ADDENDUM 2

Addendum #	2	**Date Issued**	September 18, 2026

Project Name | Job #	MSU Hoffman Auditorium Remodel	20262120

8 A021 — EXT. DOOR JAMB DETAIL
1 1/2" = 1'-0"

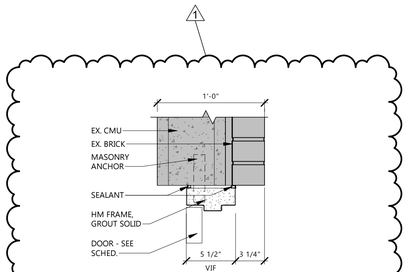
A021	**ADD** Door Head & Jamb Details 7/A021 & 8/A021.
A021	**ADD** Door Panel Type HV.
A021	**REVISE** Door Schedule for Door 104. Door 104 to be new under Alternate Bid No. 01.
A101	**ADD** Demolition Note to Door 104.
A201	**ADD** Highlight of Door 104 as new door under Alternate Bid No. 01.
E100	**REVISE** keynote 1.
E100	**ADD** Detail 2/E100 and callout on drawing.
E201	**REVISE** keynote 2.
E201	**REVISE** circuiting on receptacle under desk.
E401	**REVISE** general note F.
E802	**REVISE** light fixture P and AA.
E901	**REVISE** panel schedule LNA.
